Subject: **CORRECTION OF INTERRUPTED
 CIRCUIT**

Model: **BVM-1915**

Serial No: **2,000,231 AND HIGHER**

Figure 1

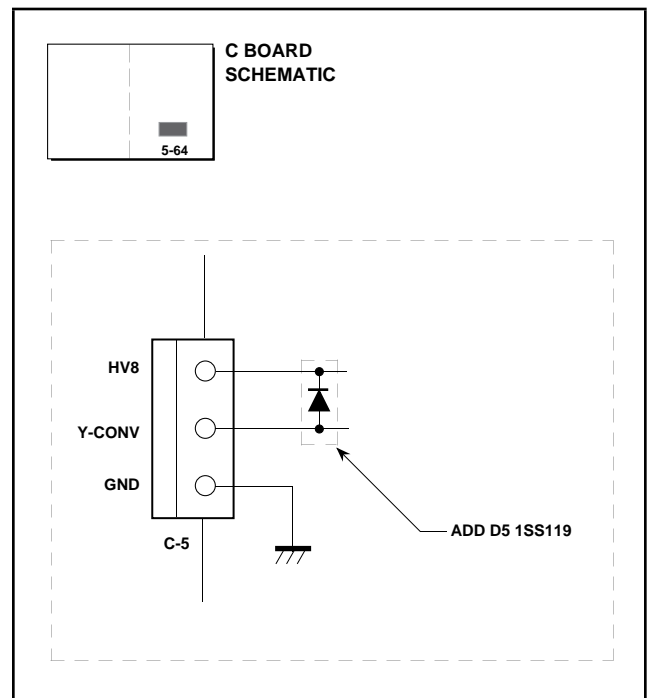
IC14 and Q2 on the DA board may fail due to electrical discharge of the high voltage current. To correct this, add diode D5 1SS119 to the C board as shown in Figure 1.

NOTE: The mounting location for D5 is already printed on the C board.
